PLAN OF PROPOSED IMPROVEMENT

HILL VALLEY - PHASE 1

CITY PROJECT NO. 15668
CONTRACT NO. 9643

REVISION 1 - 9/ 17/ 2025

U-7

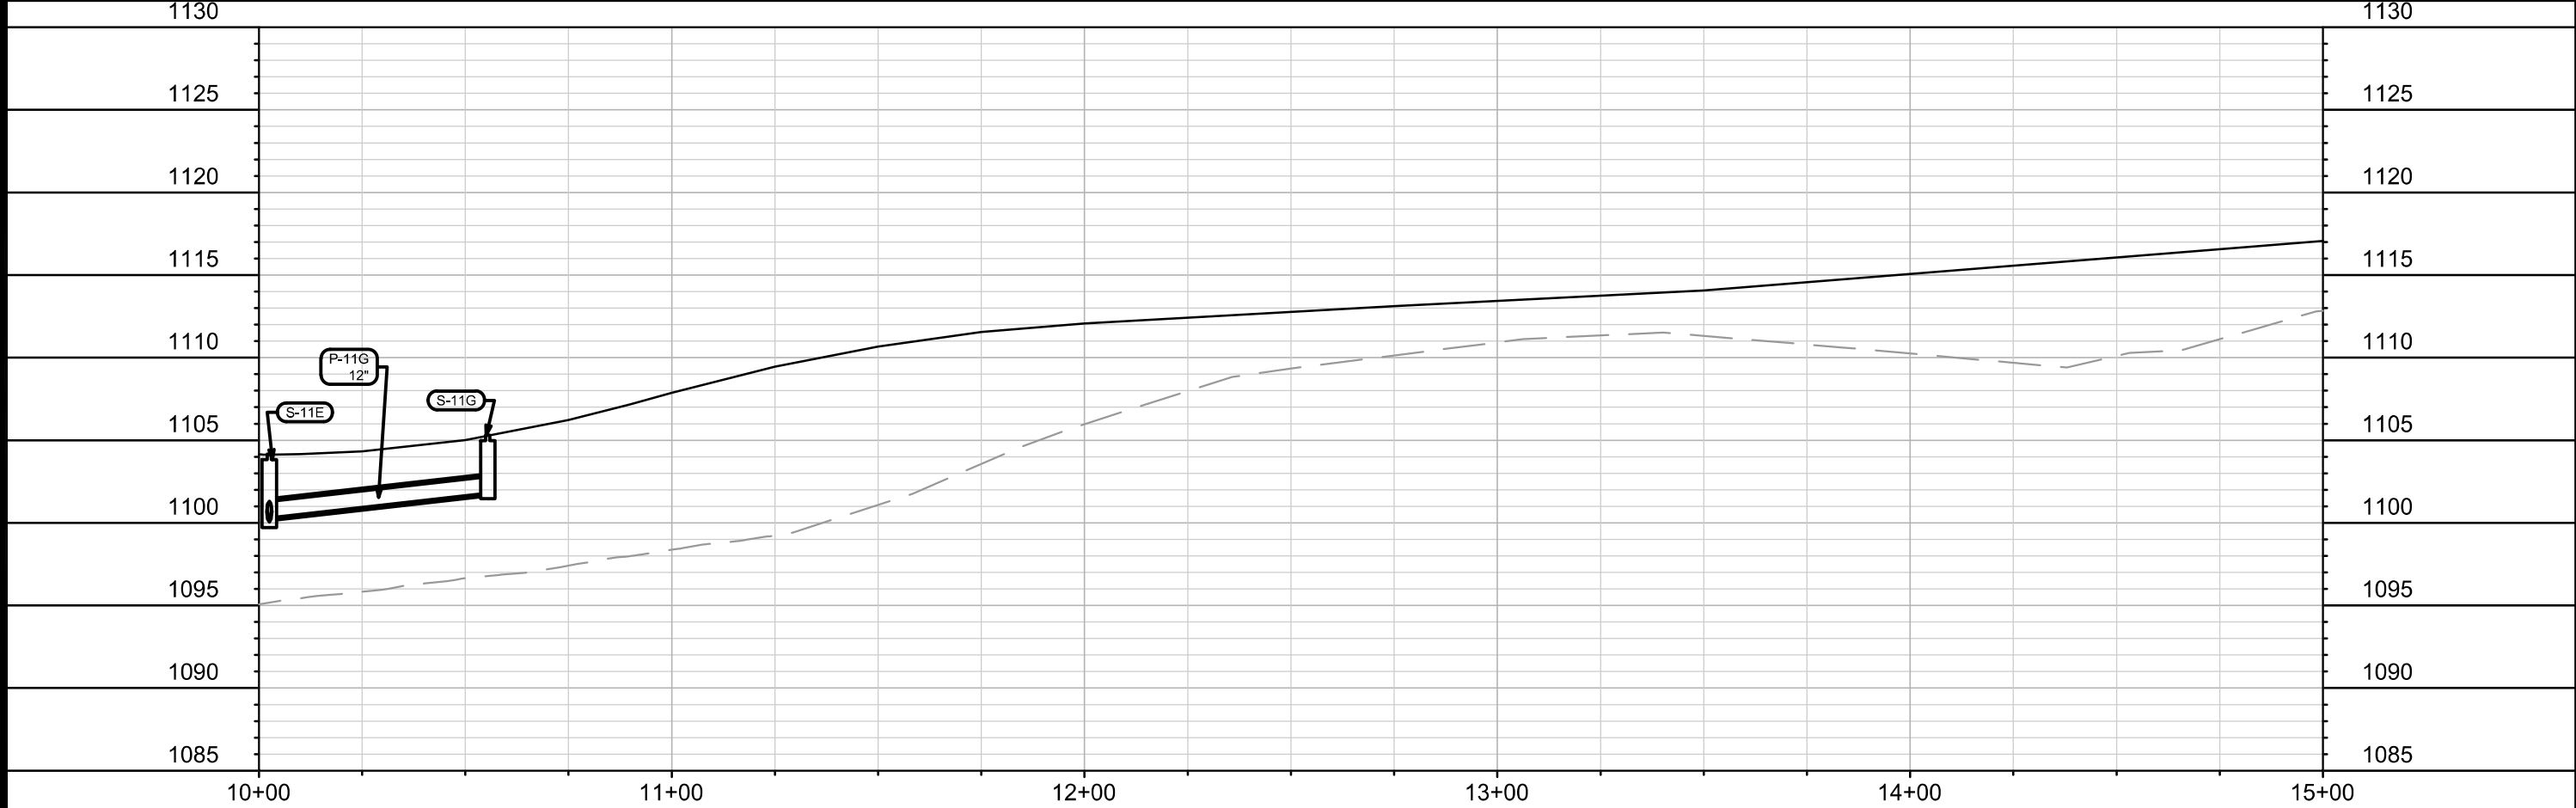
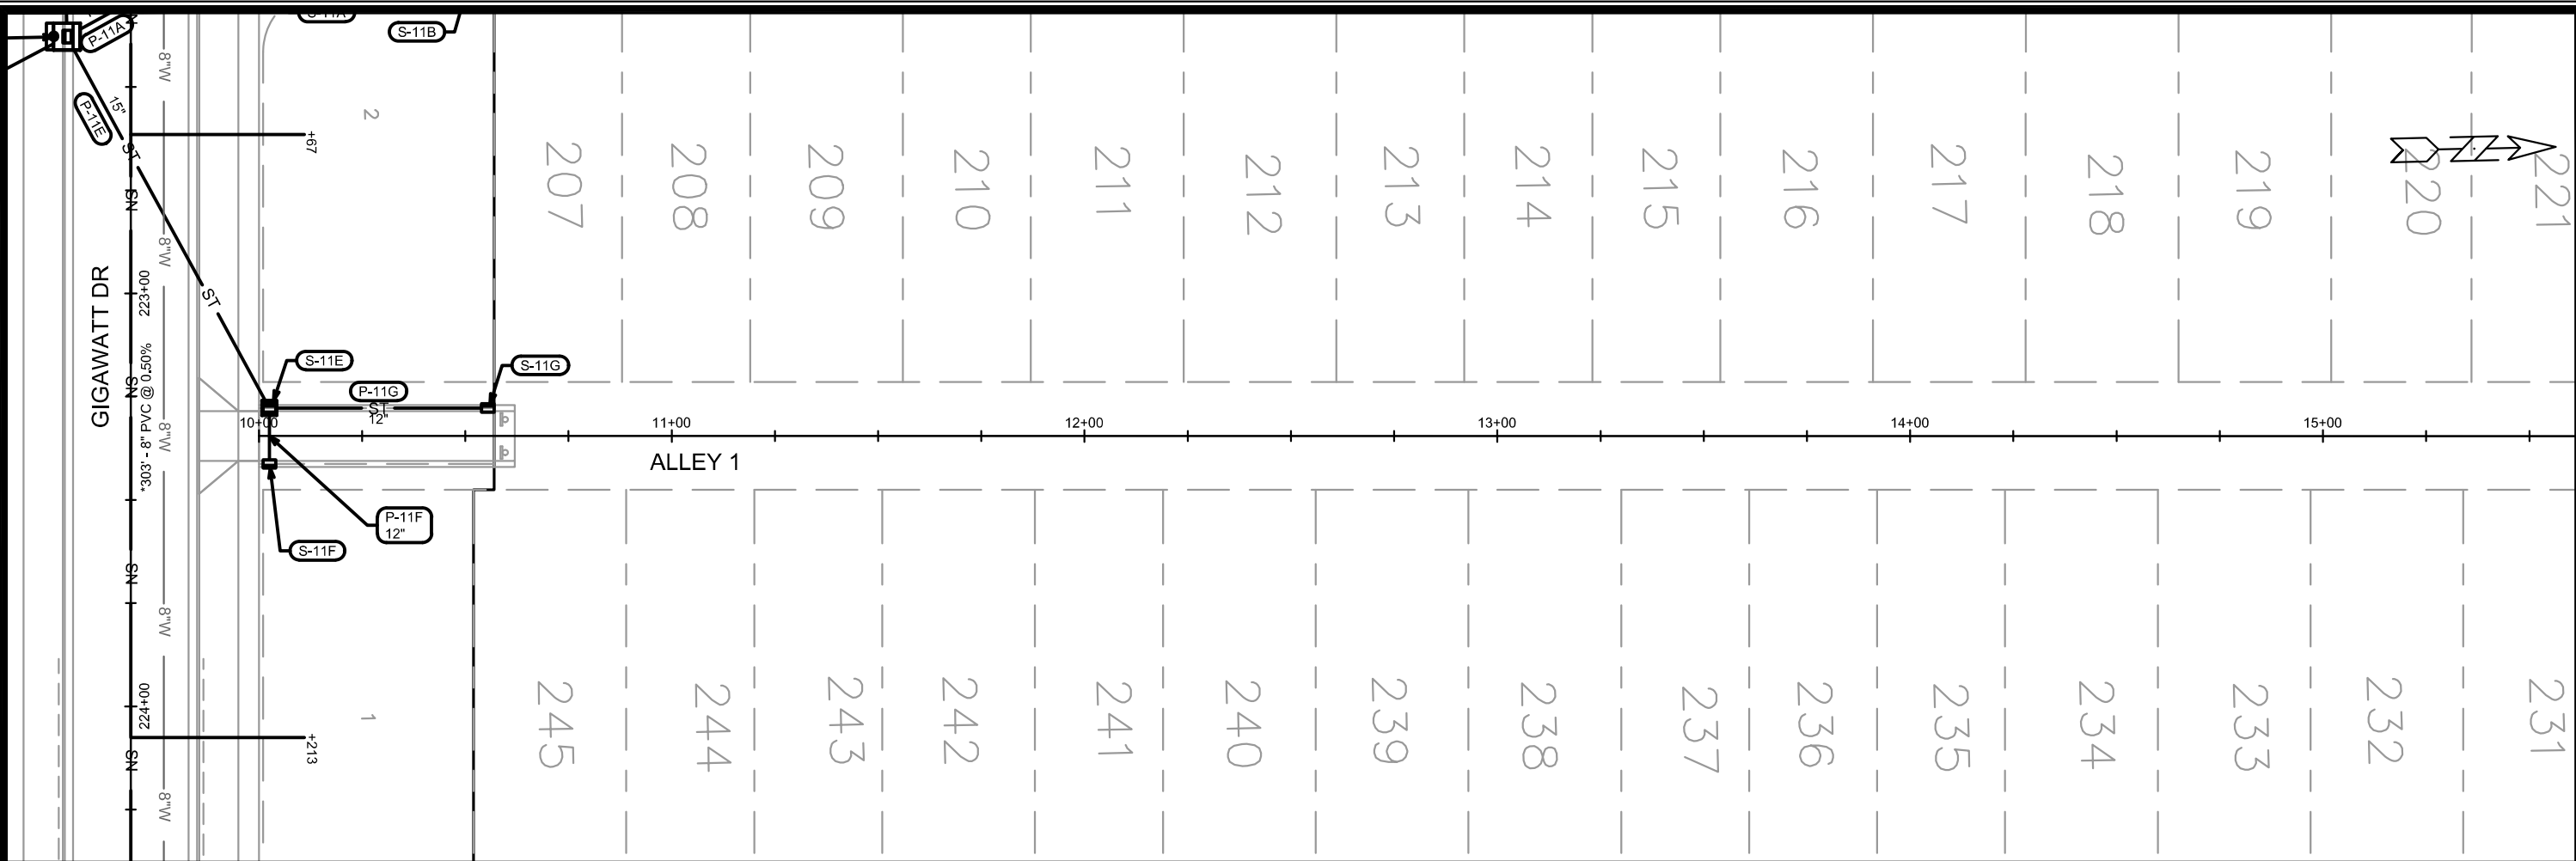
REVISED 09/17/25 - EEA
- REVISED INVERT FOR P-11D AT
STRUCTURE S-11B TO MATCH
CROWNS
